Playground Assessment Report

Location: Medford, OR

Playground Name: Children's Community Playground

Report Date: 1/25/2016

Handrail Posts

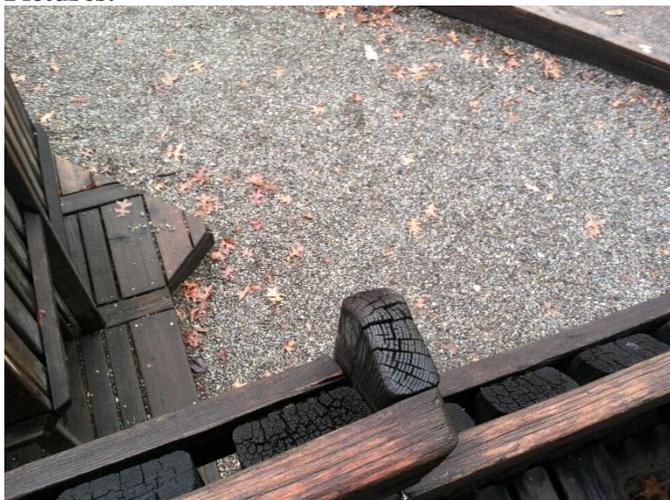
The handrail posts are in poor condition. Has major splintering and some structural issues.

Replace with recycled structural plastic.

Equipment type/name: Moving Floor

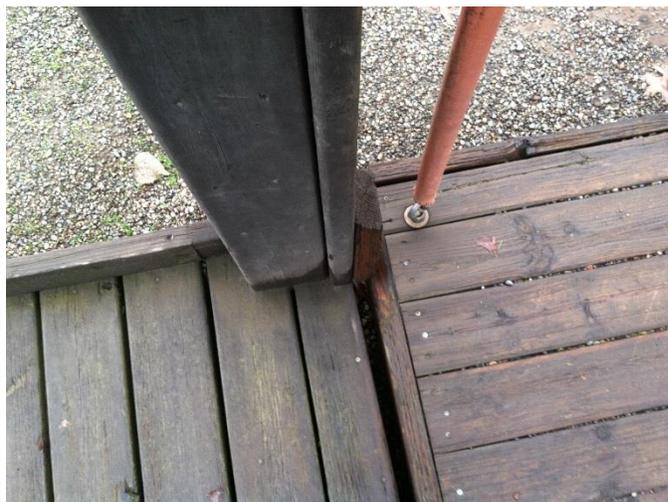
Equipment is dated

Rebuild another moving piece of equipment off the main accessible route
